ARCHITECTURAL REVIEW BOARD AGENDA

September 13, 2016 – 7:30 p.m.

STAFF REPORT

ARB Case: #2017-40000004
Applicant: Richard F. Sappington
Address: 9211 Center Street

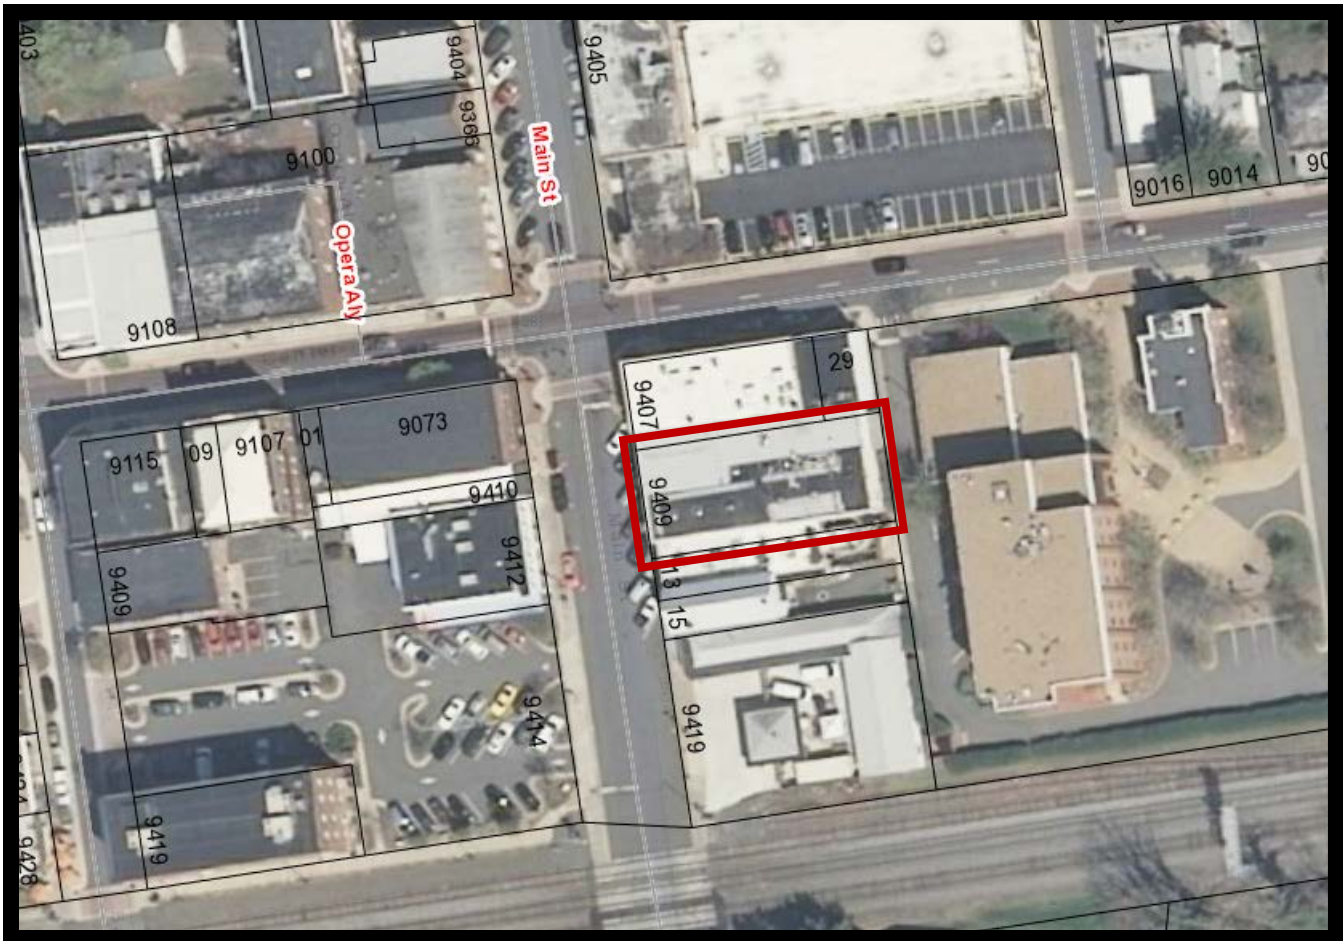
The proposed sign is sized in keeping with the recommendations of the design guidelines. The sign has been centered above the front entrance, where the placement maintains the symmetry and balance of the

elevation. It cannot be determined from the drawings where the sign will be installed in relation to the soldier course brick detailing above the entrance. In order to ensure that the bracket does not interrupt the brick detailing, it should be clarified that the bracket will either be installed above or below the soldier course detailing. Overall, the design, color palette and material are compatible with the character of the building as well as the surrounding historic district.

(2) The harmony of the proposed change in terms of overall proportion and the size and placement of elements such as entrances, windows, awnings, exterior stairs, and signs.	The sign location maintains the balance and symmetry of the elevation. In order to ensure that the sign does not interrupt the soldier course brick detailing, it should be clarified that the sign will either be installed above or below the detailing, as appropriate.

Staff recommends **APPROVAL** of the application as submitted, with the recommendation that the bracket be installed above or below the brick soldier course detailing.
